Project: WBS 42833.1.1 (B-5231)
 Bridge #162 on SR 1121 over Price Creek
 Yancey County

Subject: **MINUTES OF MEETING**

| PURPOSE/DESCRIPTION: | | Pre-Bid Meeting |

From: Wafa, Zaki H
Sent: Thursday, January 21, 2010 3:39 PM
To: 'appletuck@att.net'; 'darrell@carolinasiteworksinc.com';
'jimmysturgill@stimail.com'; 'dlrowe@triad.rr.com';
'tcbuilder@aol.com'; 'timw@waynebros.com';
'richard@carolinabridgeinc.com'; 'Bruce Horldt'; 'Kevin Burns';
'kgbryantindustries@yahoo.com'; 'Ron Grigsby'
Cc: Summers, Michael K; 'Jim Mondolfi'
Subject: Yancey 162 (B-5231) Addendum to the Minutes of Pre-Bid
Conference

STATE OF NORTH CAROLINA
 DEPARTMENT OF TRANSPORTATION
 RALEIGH
 STANDARD PRESTRESSED CORED SLAB
 60' SPAN
 27' CLEAR ROADWAY - 60° SKEW

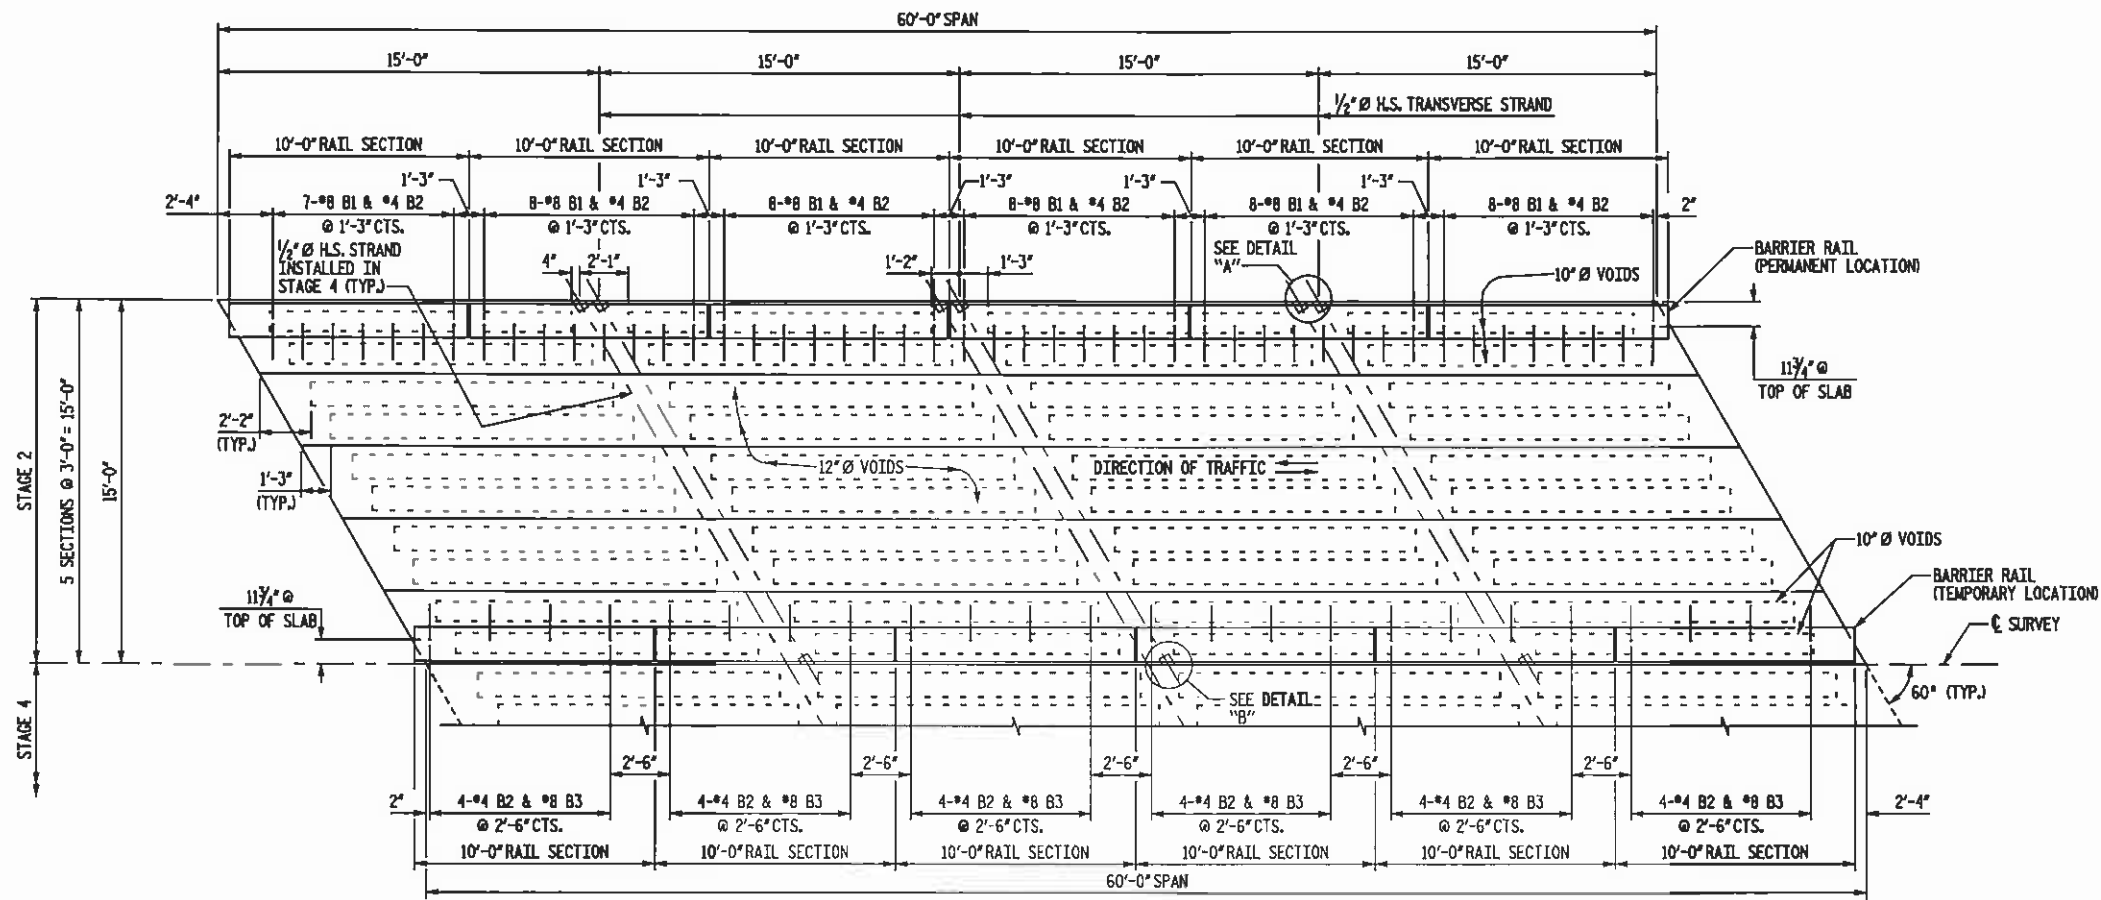
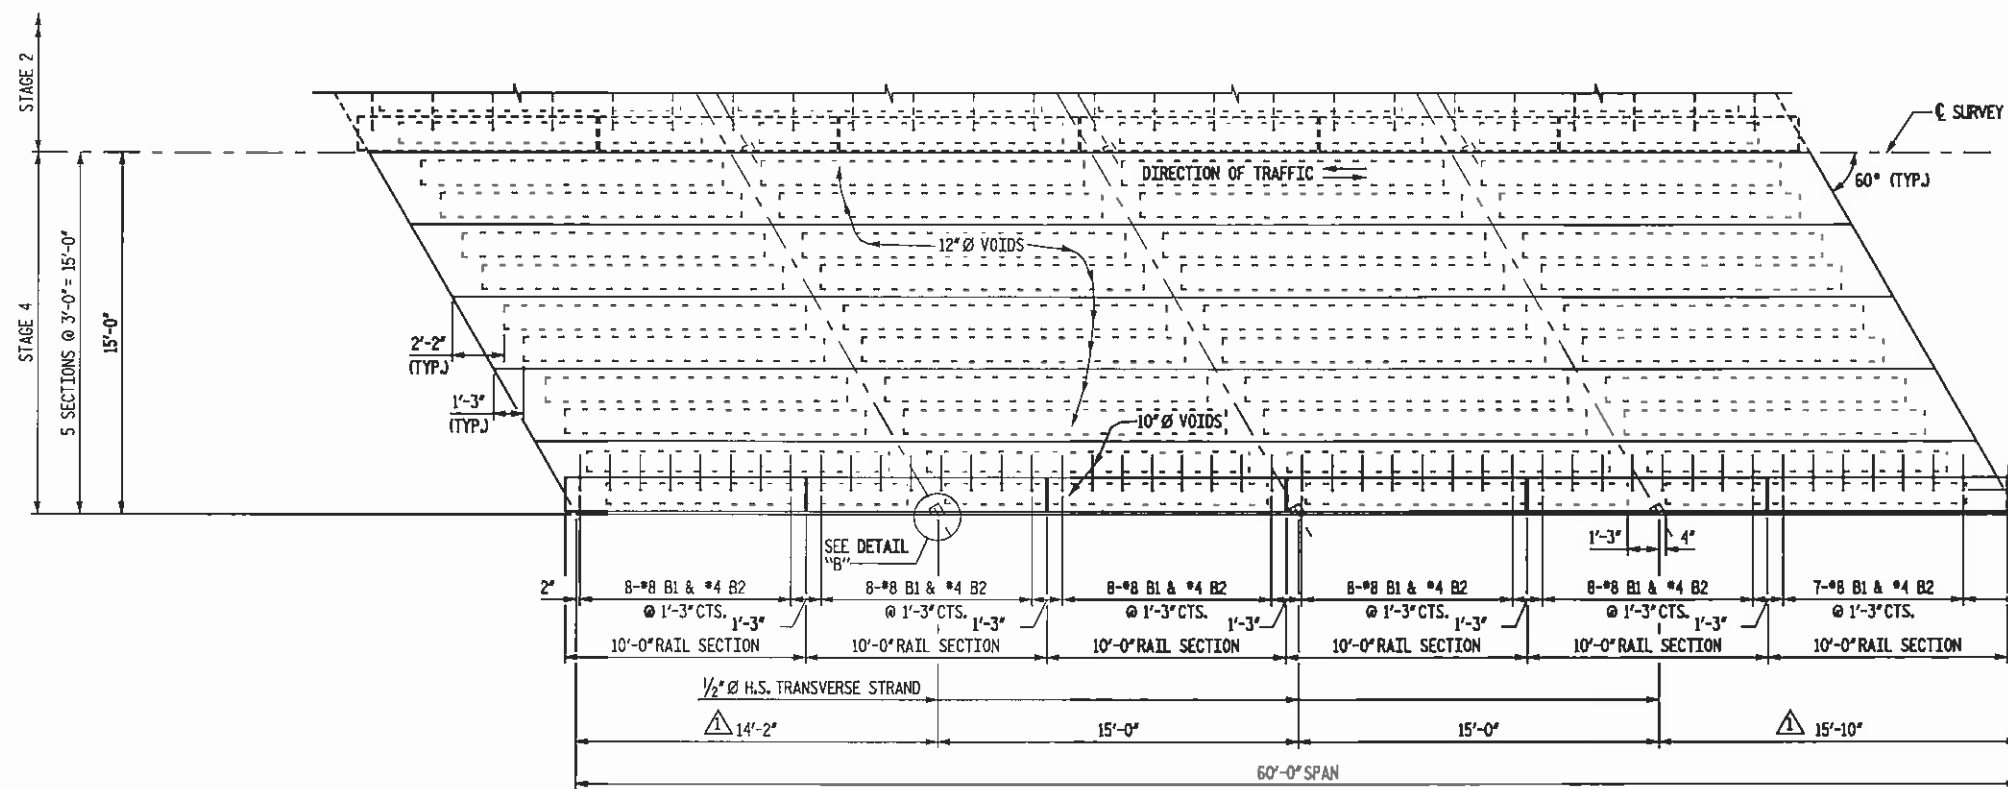
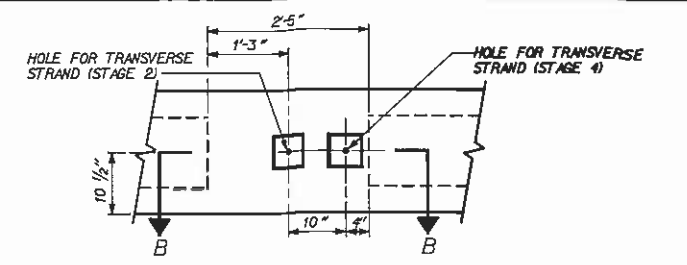
- 1) Revised Drawing 3 of 31 indicating cored slab details is attached.
- 2) Revised Drawings 4, 5, 6, 7, 8, 9, 13 & 13A was distributed to all attendees at the meeting. A complete set of drawings with revisions will be resubmitted to the BMU.
- 3) Page 5 in the Bid Proposal Document should read "Bids received after 2:00 pm, Tuesday, January 26, 2010 will not be accepted".
- 4) The existing bridge components will be removed and disposed of by the Contractor.

| STATE OF NORTH CAROLINA DEPARTMENT OF TRANSPORTATION RALEIGH | | | | | |
|--|-----|----------|-----|----|------|
| STANDARD PRECAST CONCRETE BARRIER RAIL SECTIONS 60' SPAN 27' CLEAR ROADWAY - 60° SKEW | | | | | |

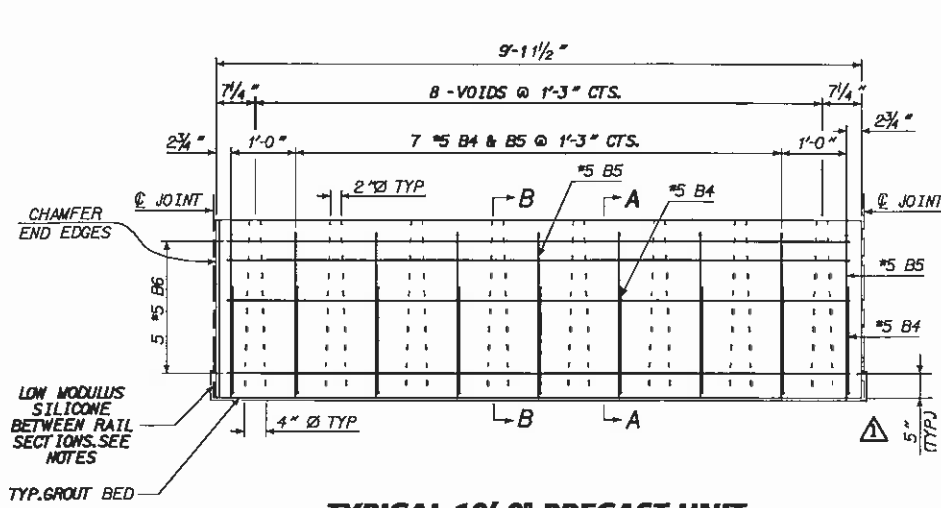
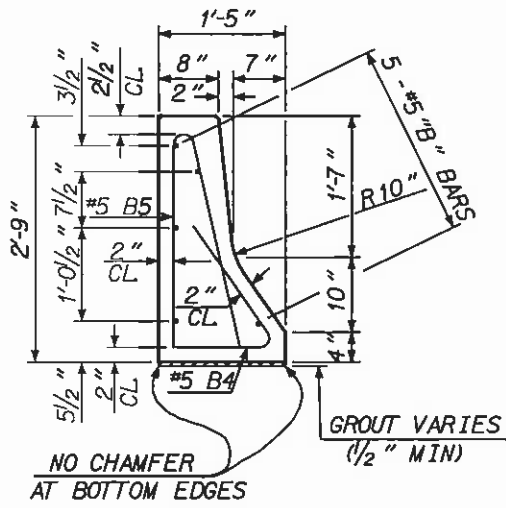
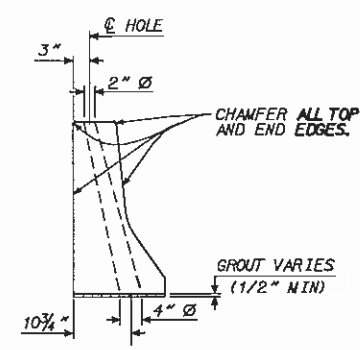
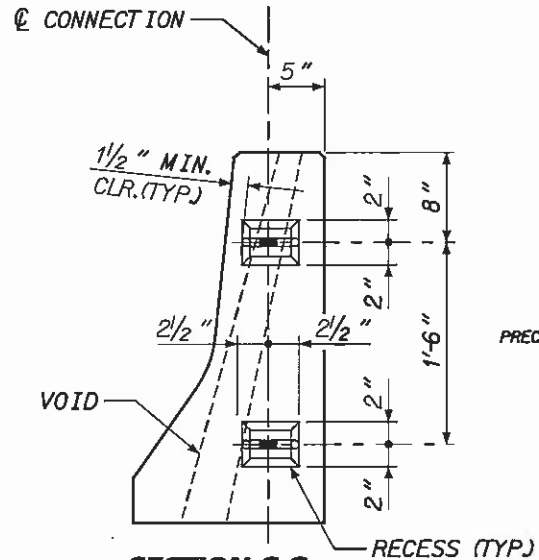
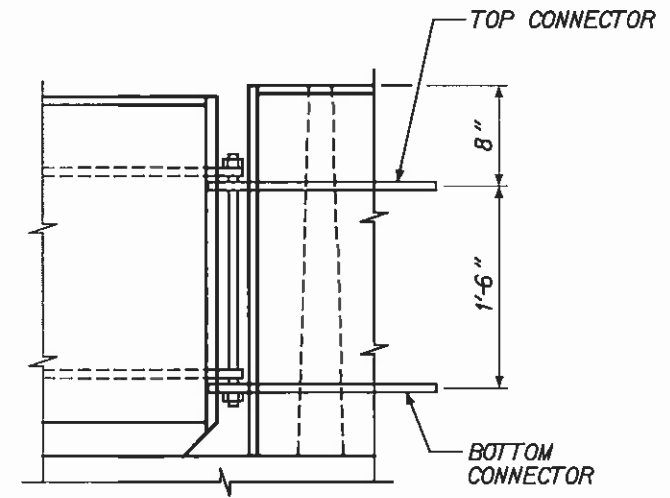
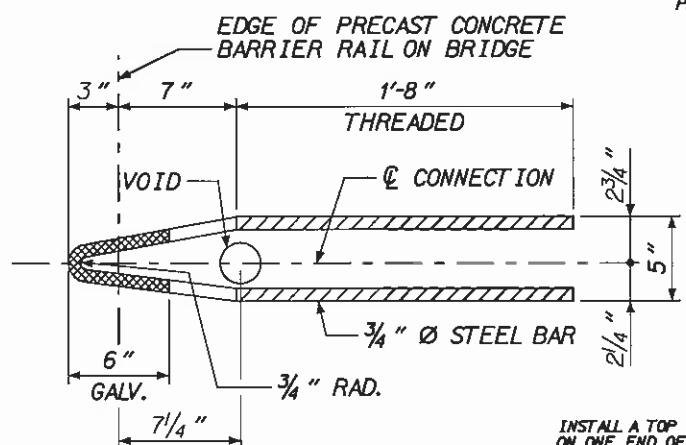
△ ADDED #5 INCH DIMENSION
REVISED NOTES
REVISED PLAN OF BARRIER RAIL DETAIL

INSTALL A TOP CONNECTOR AND A BOTTOM CONNECTOR ON ONE END OF THE BRIDGE BARRIER RAIL UNIT, USED AS A TEMPORARY BARRIER RAIL FOR STAGE 4 CONSTRUCTION, LOCATED AT THE BEGINNING AND AT THE END OF THE BRIDGE.
AFTER MOVING THE BARRIER RAIL TO IT'S PERMANENT LOCATION IN STAGE 5, CUT THE 3/4" Ø BAR CONNECTOR FLUSH WITH THE CONCRETE SURFACE. FILL RECESS WITH NON-SHRINK, NON-METALLIC GROUT TO THE NEAT LINE OF BARRIER RAIL UNIT.

STATE OF NORTH CAROLINA
DEPARTMENT OF TRANSPORTATION
RALEIGH
SUPERSTRUCTURE
GUARDRAIL ANCHORAGE
DETAILS

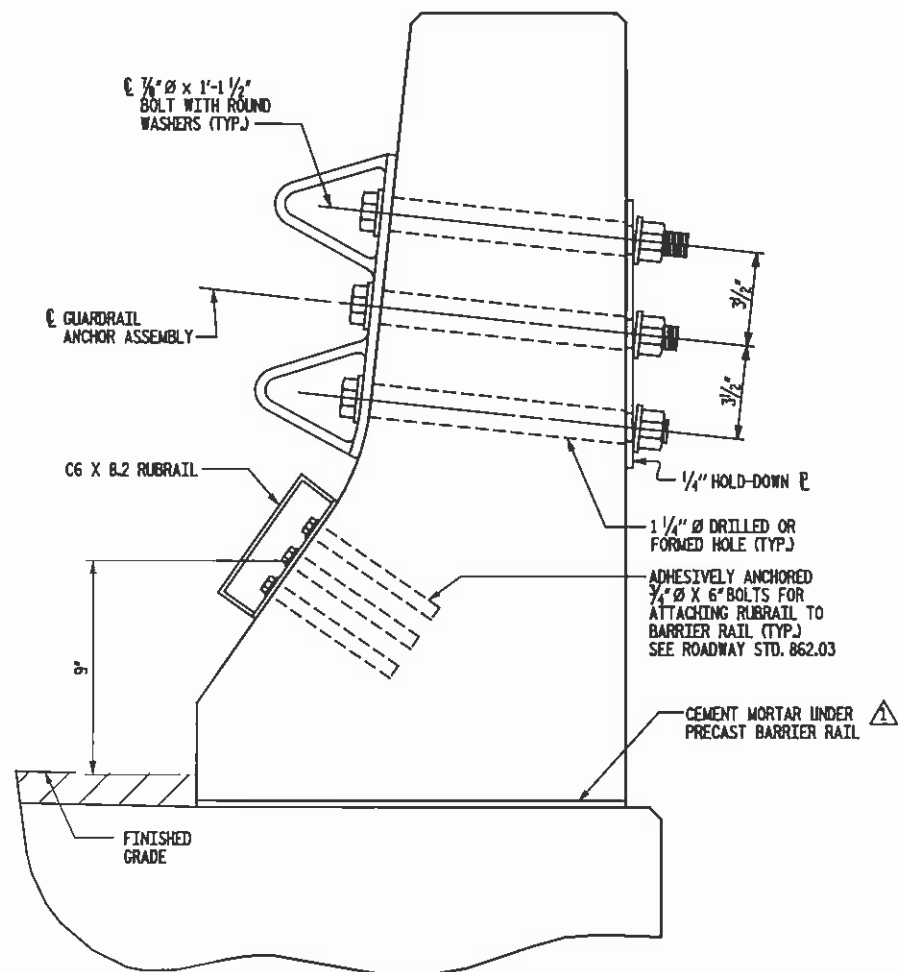
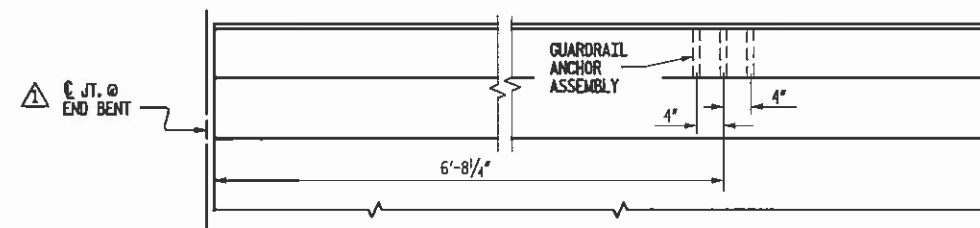
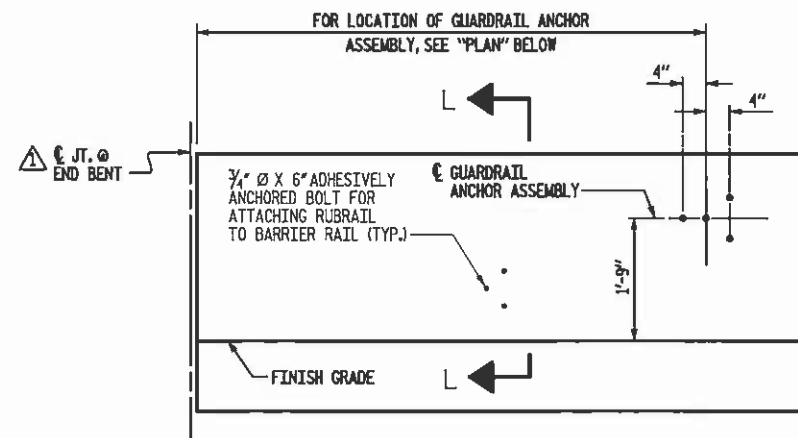
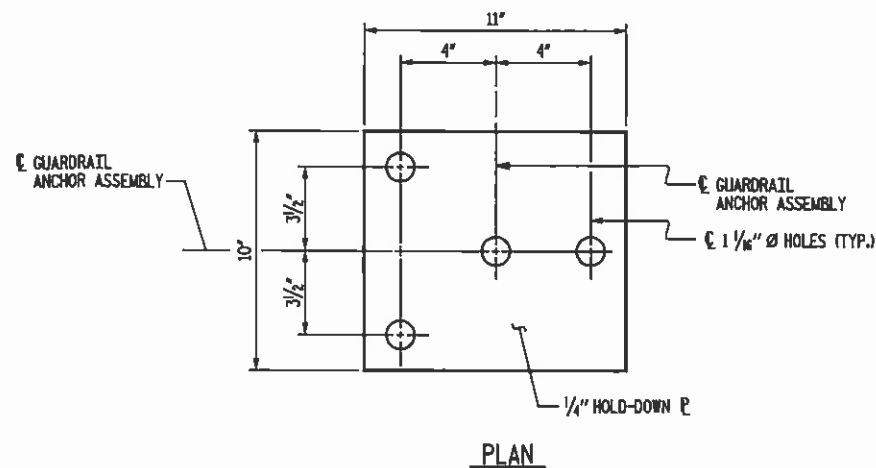
- △ REVISED NOTE.
- REVISED DESCRIPTION CALLOUT.
- ADDED MORTAR NOTE.

△ THE COST OF THE GUARDRAIL ANCHOR ASSEMBLY SHALL BE INCLUDED IN THE UNIT CONTRACT PRICE BID FOR GUARDRAIL ANCHOR UNIT TYPE B-77.
